DISTRICT –WIDE EMERGENCY BLUE PHONES

BID NO. 16-17/23

Peralta Community College District

ADDENDUM No. 2

TRENCH PROFILE.

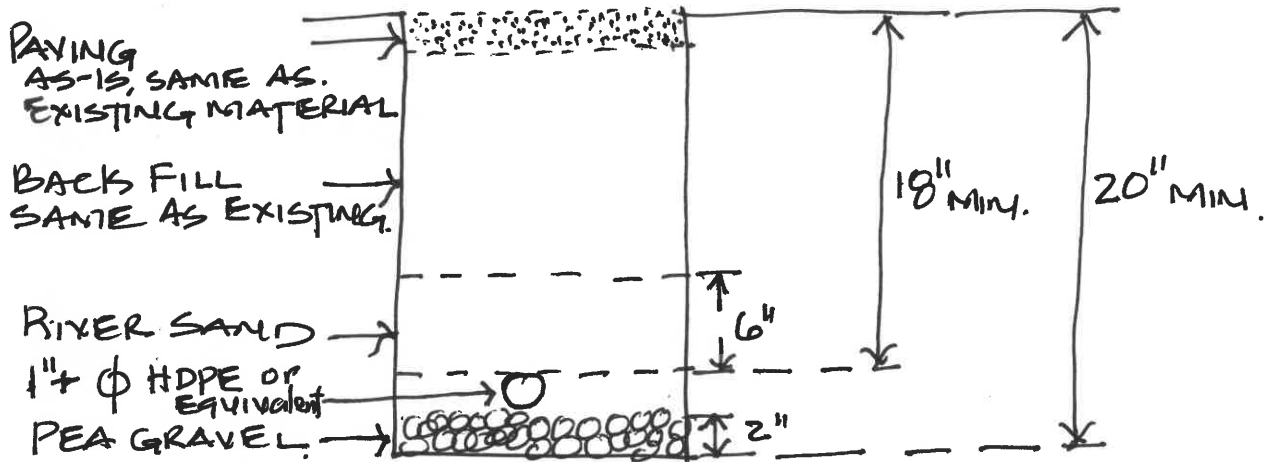
3. There are no specifications or details regarding the trenching for the underground conduit work. Can you provide a detail that shows trench depth, type of backfill or some expectations of how you wish us to accomplish this scope?

*Reply: The specification calls for a **total trench depth** of minimum twenty (20") inches; while trench depth to the top of buried conduit of a minimum of eighteen (18") inches; a river sand back fill of six (6") inches above the top of the buried conduit; the buried conduit should sit on two (2") inches of gravel (pea size). The estimated diameter of underground conduit (HDPE or equivalent) will be a minimum of one (1") inch to accommodate low voltage cable. The backfill will be same earth material dug up during trenching. The backfill shall be compacted. The final paving shall be same as pre-existing material prior to trenching –in the parking lot, it will be asphalt for asphalt or grass or concrete as it may pre-exist in other areas. **See Attachment #1.***
